# Product Change Notification

Product Change Notification: E-17-018155

PCN Date: 14-DEC-17

SSR 240/480 V, AC/DC Hockey puck, inverse parallel SCR output Solid State Relays

SSR-image

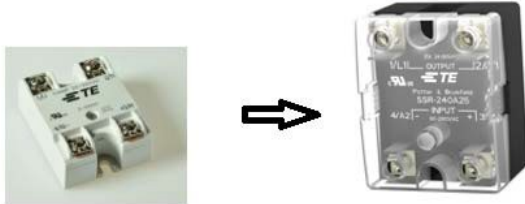
Input parameters changed from 3-32VDC to 4-32VDC for 50A and 125A. Single cycle surge current changed from 250A to 300A for 25A, 240V and 400A for 25A 480V. Single cycle surge current changed from 750A to 520A for 50A. Single cycle surge current changed from 1700A to 1150A for 125A. Static dv divided by dt changed from 500 to 300V divided by microseconds for 25A, 240V. Static dv divided by dt changed from 500 to 1000V divided by microseconds for 50A and 125A. I2T Rating changed from 937 to 510A2sec for 25A, 240V and 800A2sec for 25A, 481V. I2T Rating changed from 2458 to 1350A2sec for 50A. I2T Rating changed from 12000 to 6600A2sec for 125A. Color is changed from white to black. Using snubber output. Finger protection cover made default. Manufacturing location is also changed.
